SUMMARY EXPERT OPINION INDEPENDENT CERTIFICATION: OVERSHADOWING ANALYSIS

PROPOSED MULTI RESIDENTIAL DEVELOPMENT 10-14 Merton St Sutherland

22 December 2014

Figure 1: View from the sun 12 noon

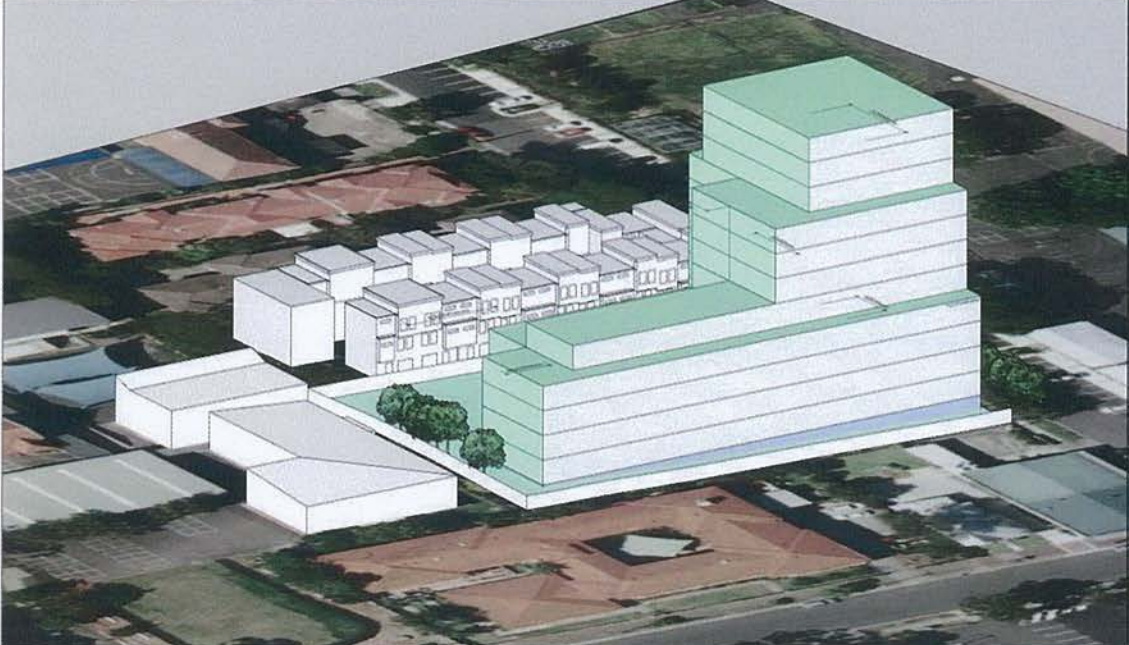
I have prepared my own hourly views from the sun for the architects' preferred option. The technique is illustrated in Figure 1. I attach a table of hourly views from the sun of Option 2, in Appendix A.

Figure 2: Critical envelope limits, Option 2 view from the sun 12 noon June 21

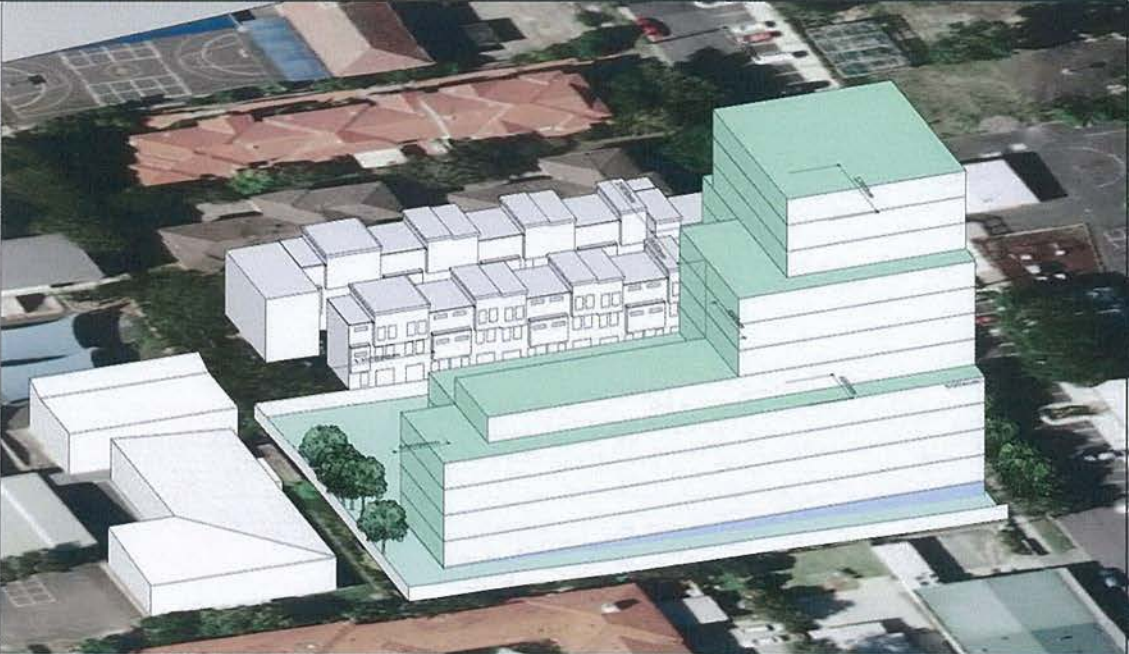
I refer again to my preferred technique of 'views from the sun'. Figure 2 uses the same base as Figure 1, but is annotated with some key considerations.

A Critical tower height:

- If tower is *taller*, it will have impacts to the south beyond that of the existing townhouses.
- *Reduction* in tower height does not make a significant difference in overshadowing of townhouses on immediately adjacent site.

B Critical podium height and location:

- Relevant parapet heights of podium in this location preserve solar access to ground floor of townhouses to the south of the subject site.

C Minimise overshadowing of schools to the east and west:

- In the middle of the day there is no overshadowing impact on the adjacent schools;
- The morning shadow to a portion of the playground of the primary school is determined by the plan, not the height of the 'tower';
- The afternoon shading of St Patrick's is from the identical 'podium' portion and is insensitive to the tower height.
